NO: CON-019 **PRODUCT:** XS2F, XS2W Connector Cordset
DATE: November 2015 **TYPE:** Modification Notice

XS2F/XS2W 4-pin Cordsets Modified with 5-pin Connectors; 5-pin Cordsets Modified to Prevent Loose Connections

Effective Date: November 1, 2015 production

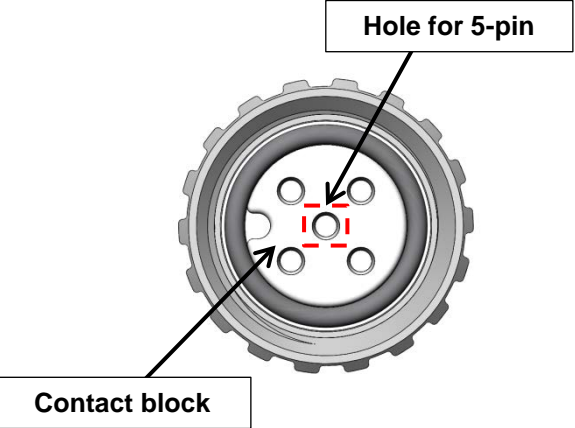
Reasons for modifications:

For 4-pin connector cordsets, they will be able to accept a 5-pin plug connector to mate with the 4-pin socket connector.

For 5-pin connector cordsets, socket construction was modified with notches to prevent vibration from loosening the connection. This construction was already applied to 3-pin and 4-pin cordset connectors.

Changes

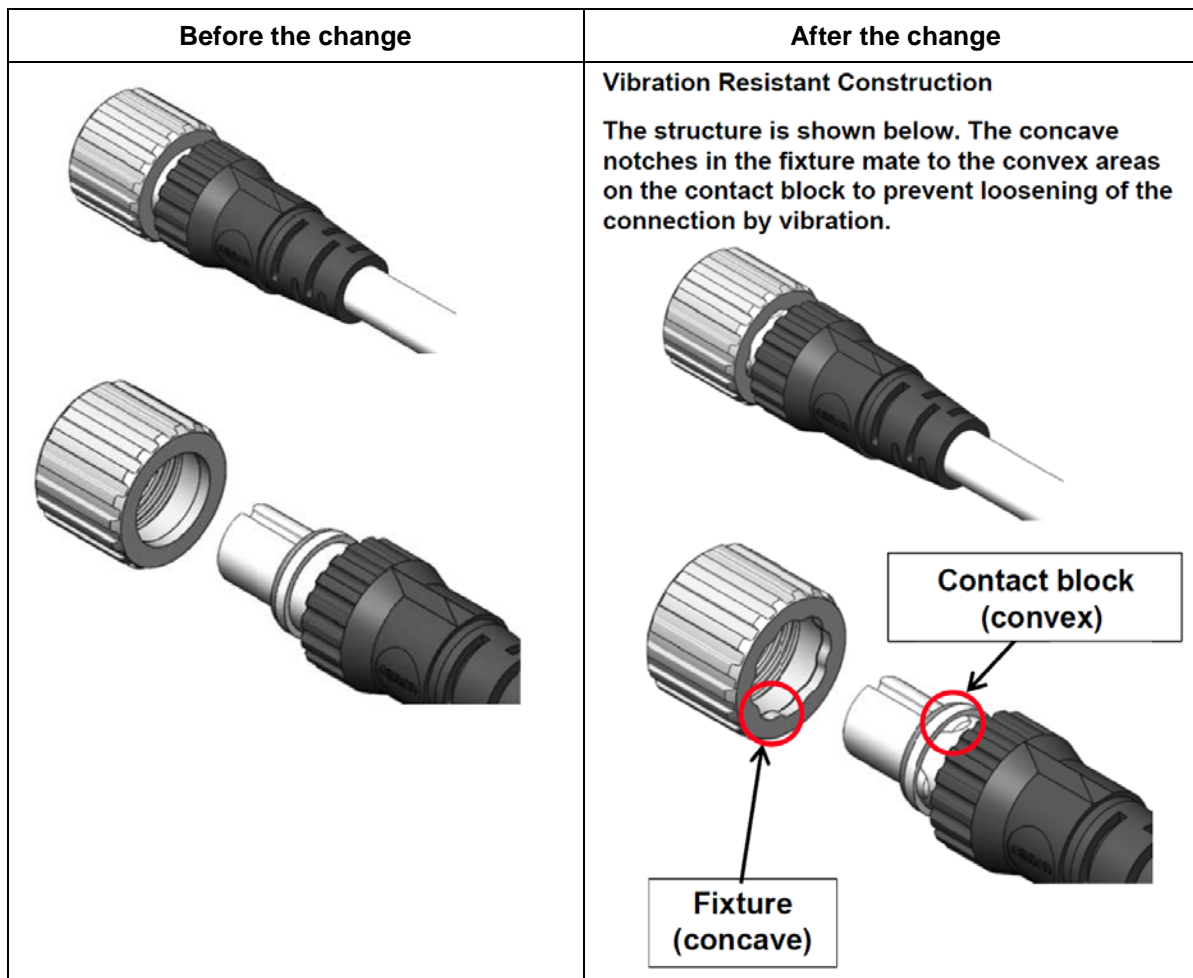
4-pin Cordsets Modified with 5-pin Sockets

Before the change	After the change
	<p data-bbox="805 1098 1393 1186">There is now a hole in the center of the contact block so a 5-pin plug connector can be mated with a 4-pin socket connector.</p>

5-pin Cordsets Modified with Vibration Resistant Connection
